**PRELIMINARY/FINAL DRAINAGE REPORT**

**LOTS 1 & 2, SPACE VILLAGE FILING NO. 3**  
**6809 SPACE VILLAGE AVENUE**  
**EL PASO COUNTY, COLORADO**

**September 8, 2017**

**Olsson Project No. 017-1754**

## Map Unit Descriptions

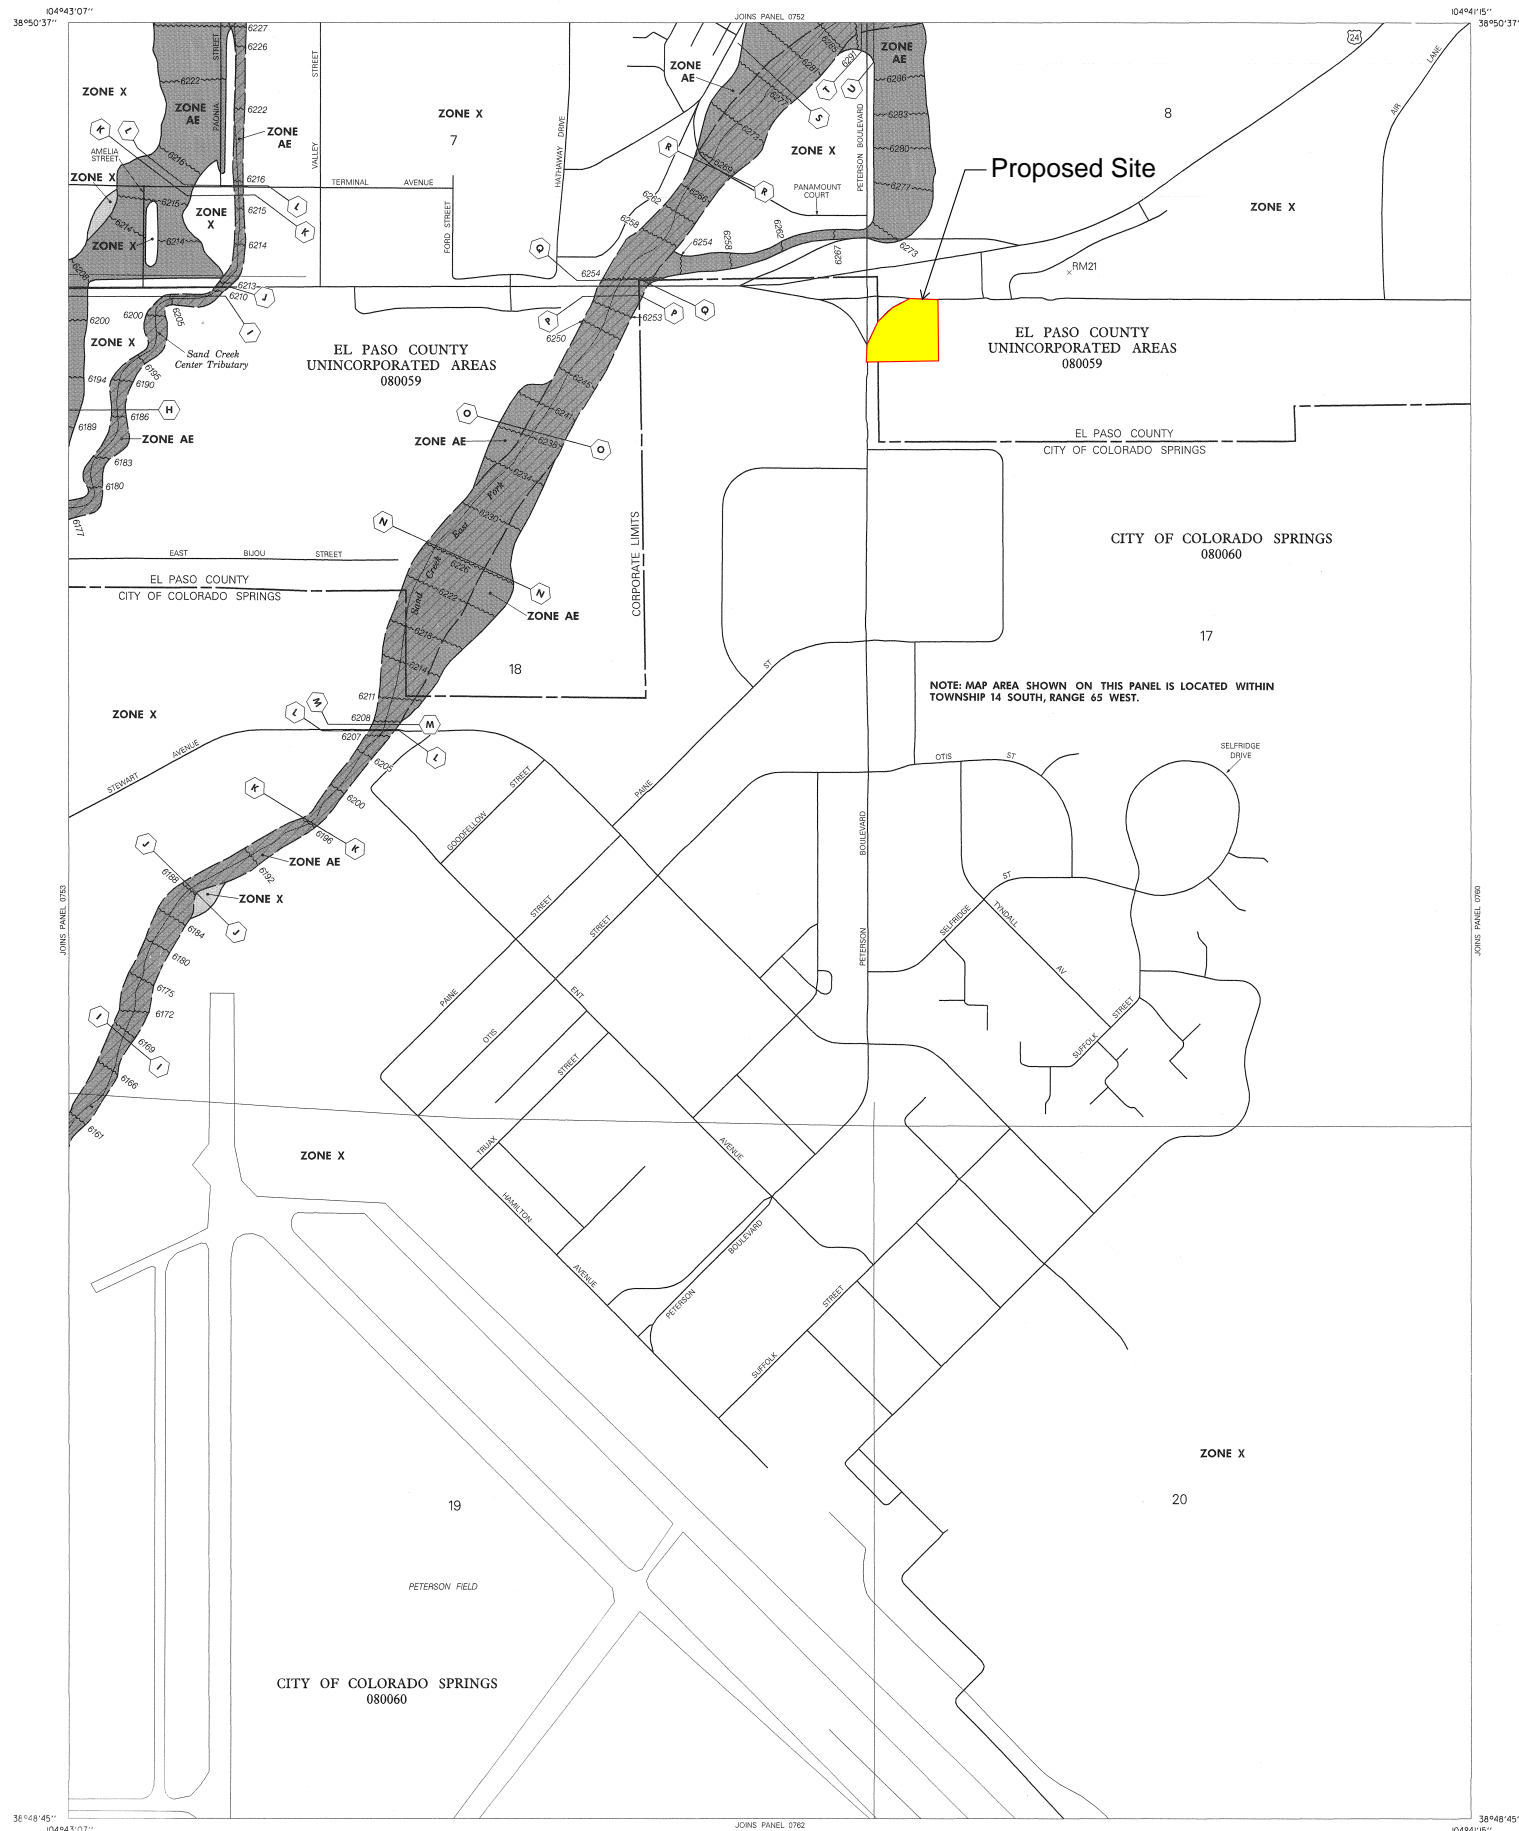
Include the section of the NRCS  
Report that identifies the Hydrologic  
Soil Group.

**DETENTION BASIN STAGE-STORAGE TABLE BUILDER**

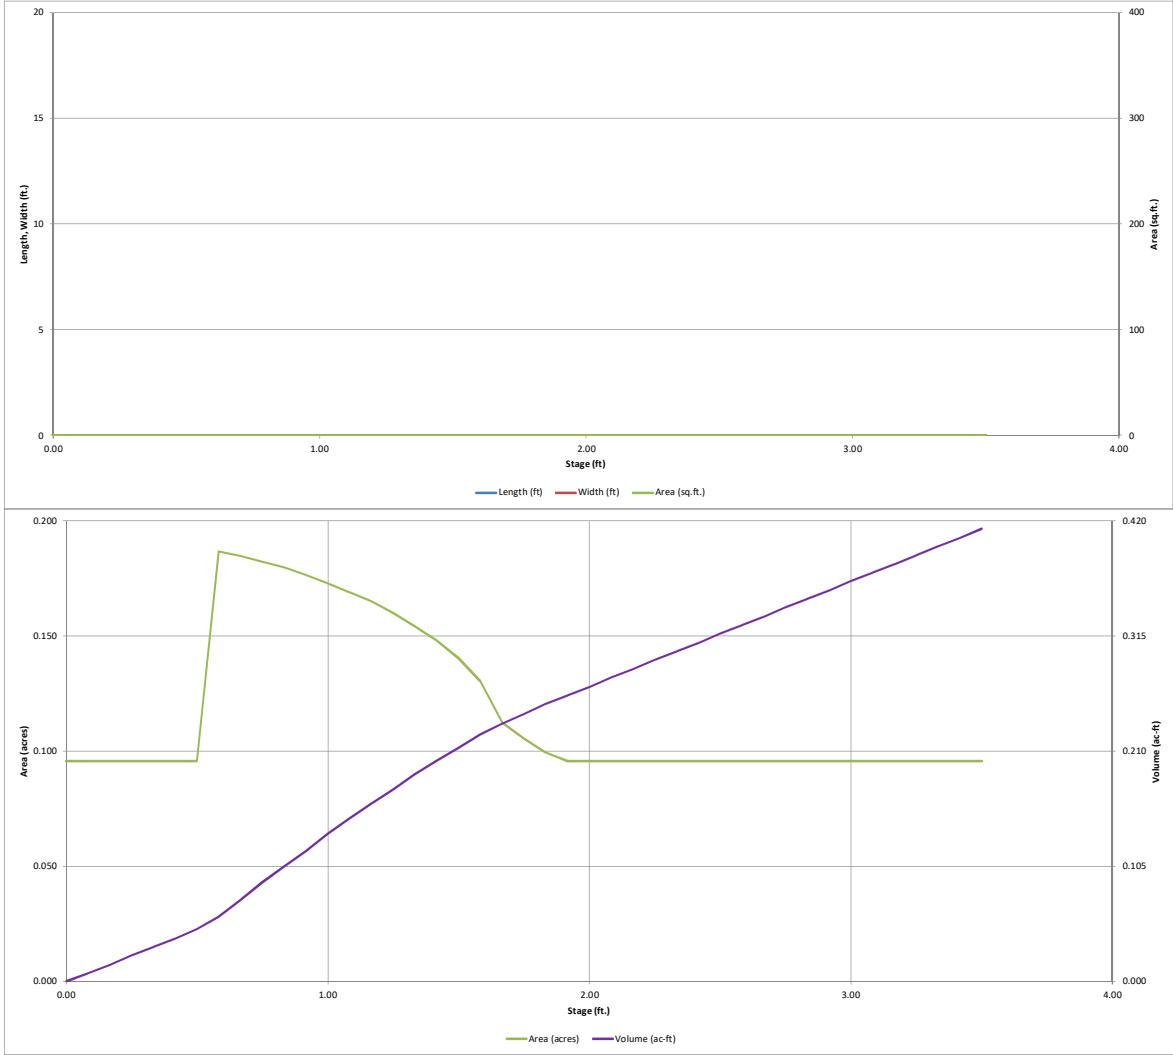
Replace based on the City DCM Chapter 6 Table 6-2.

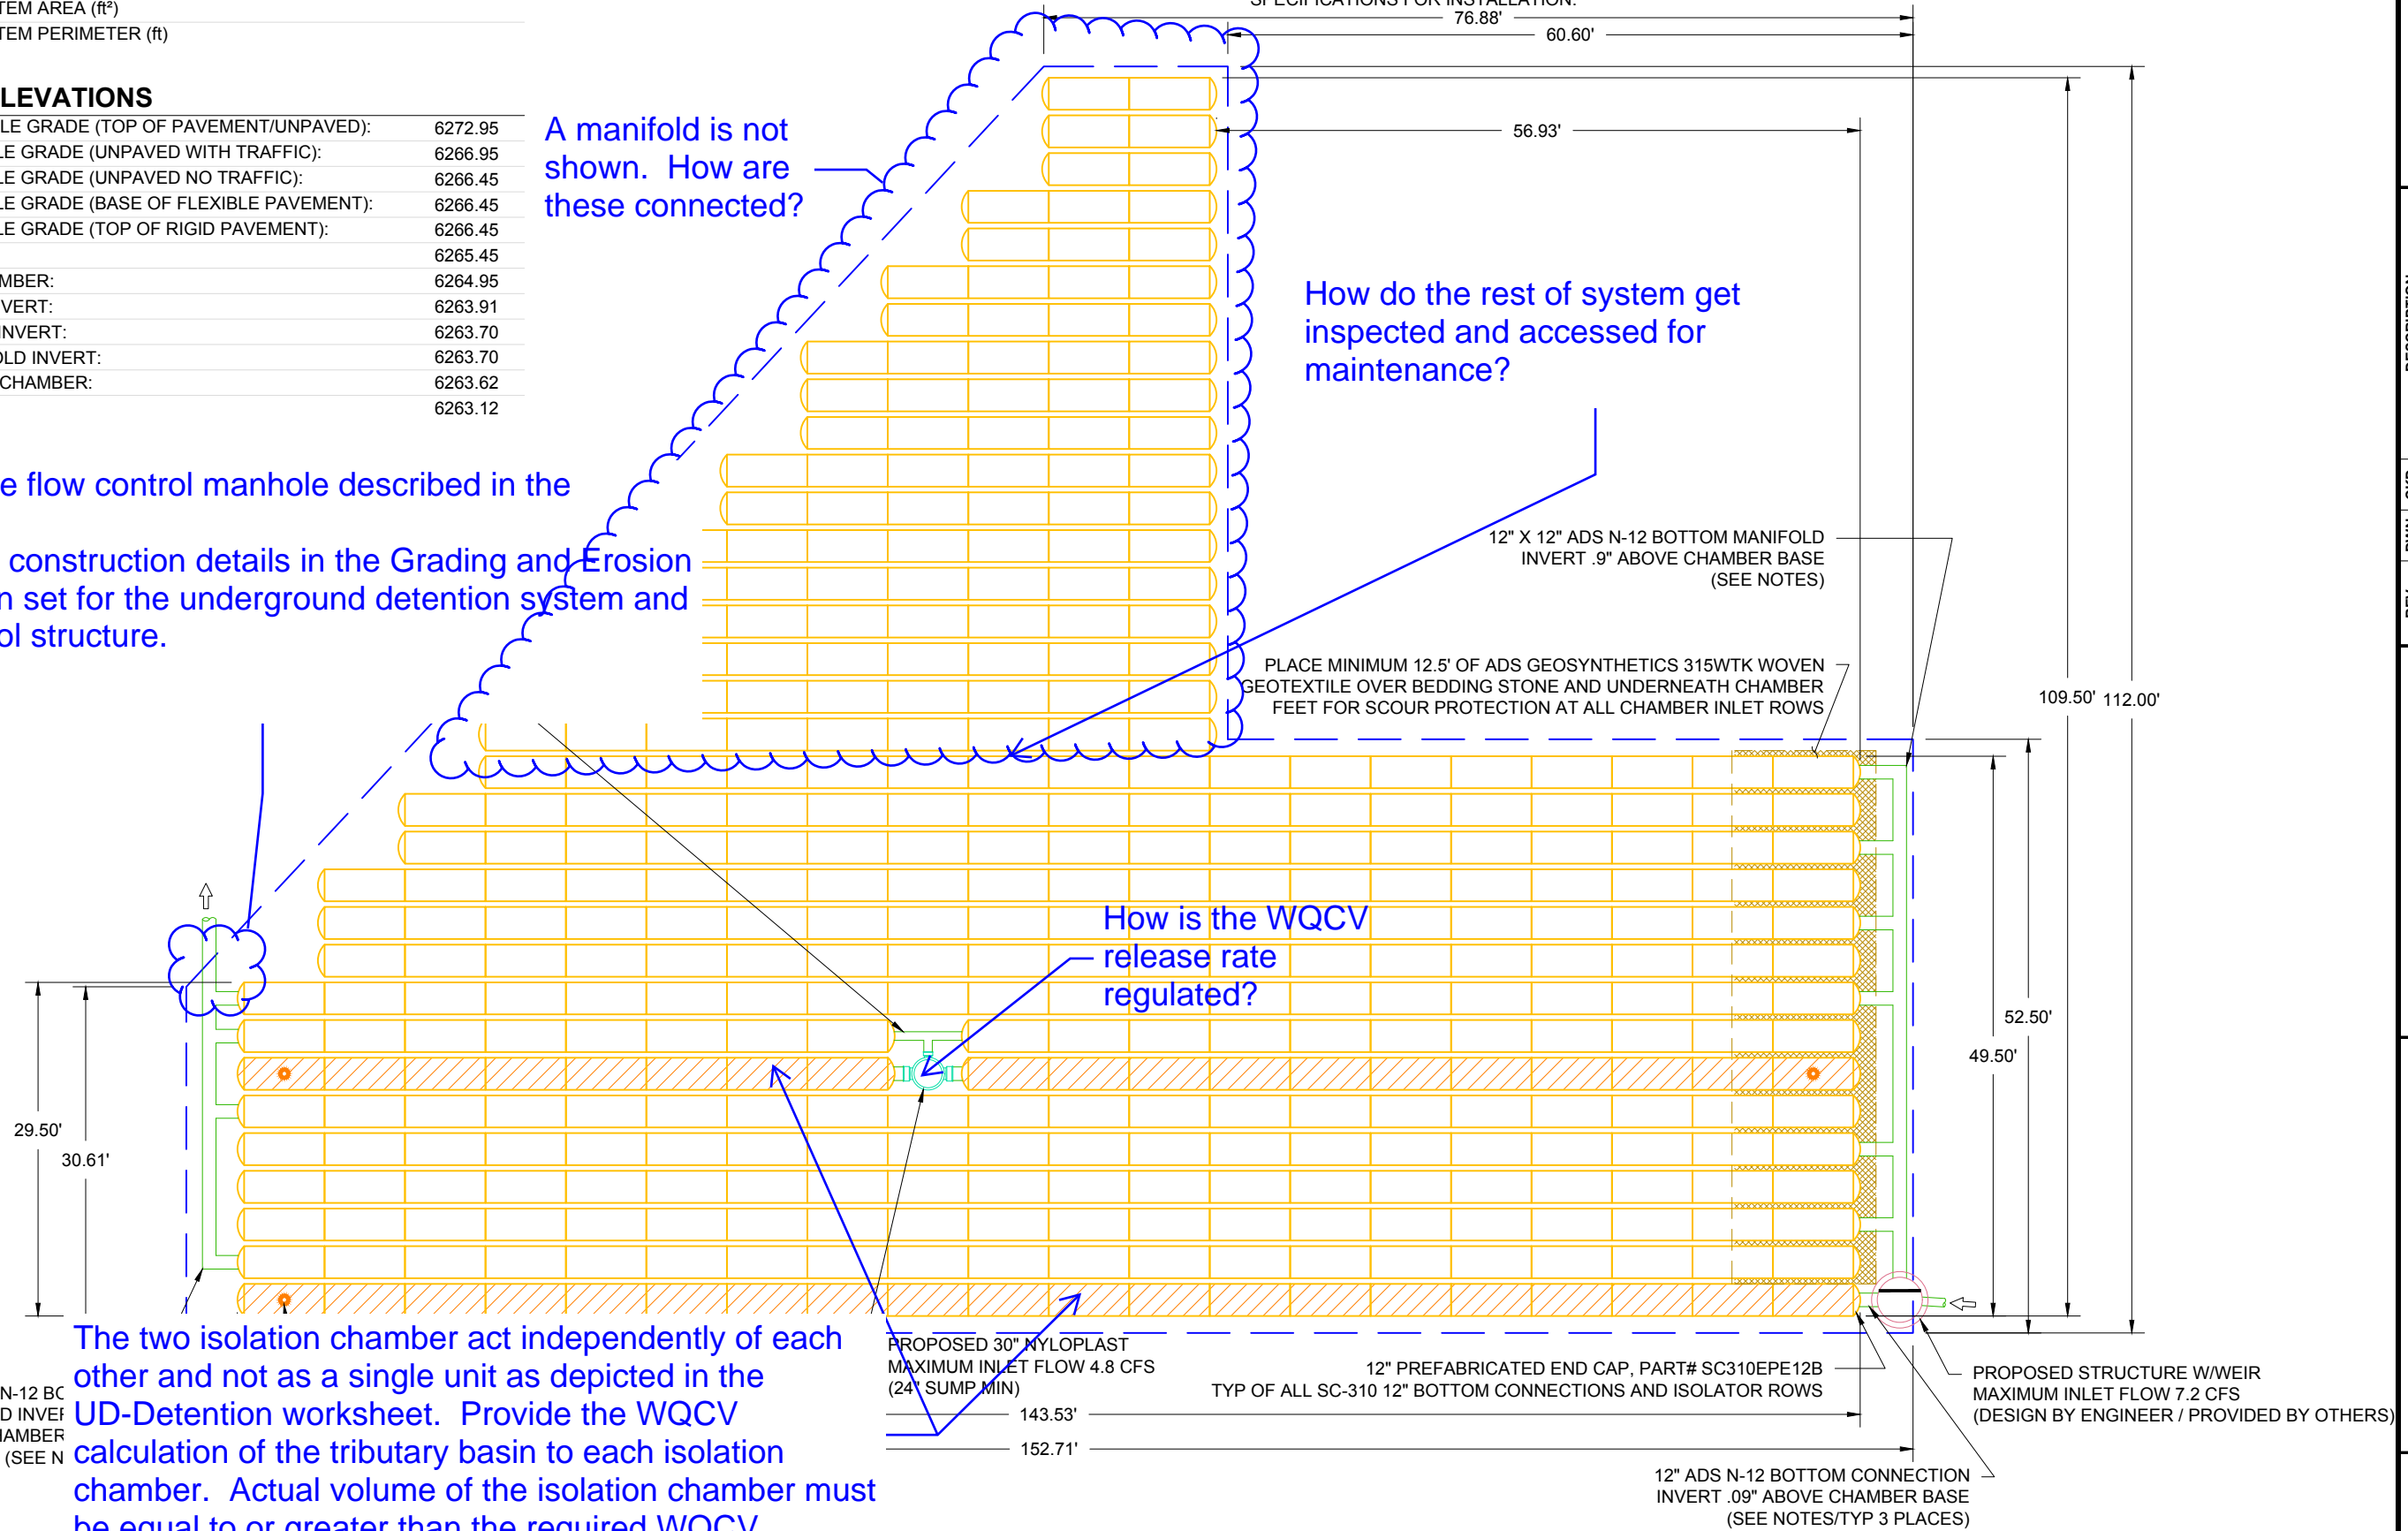
Where is the flow control manhole described in the narrative?  
Provide the construction details in the Grading and Erosion Control Plan set for the underground detention system and outlet control structure.

A manifold is not shown. How are these connected?

The two isolation chamber act independently of each other and not as a single unit as depicted in the UD-Detention worksheet. Provide the WQCV calculation of the tributary basin to each isolation chamber. Actual volume of the isolation chamber must be equal to or greater than the required WQCV.

**SC-310 ISOLATOR ROW DETAIL**

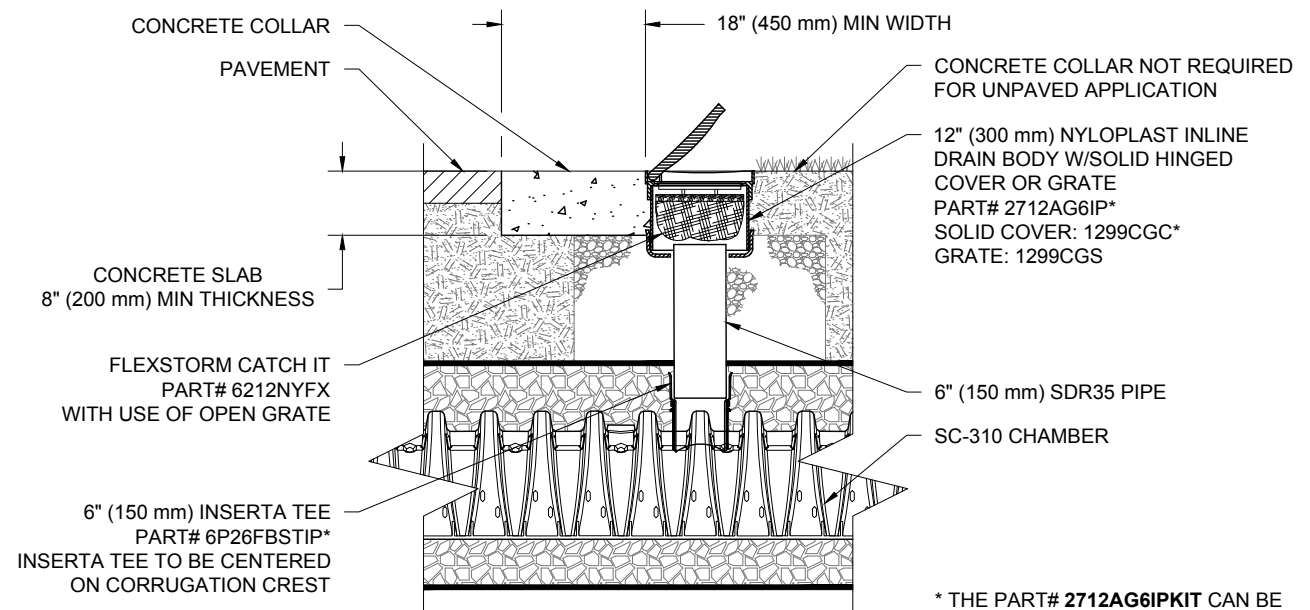
Provide a definitive design statement instead of stating recommendation.
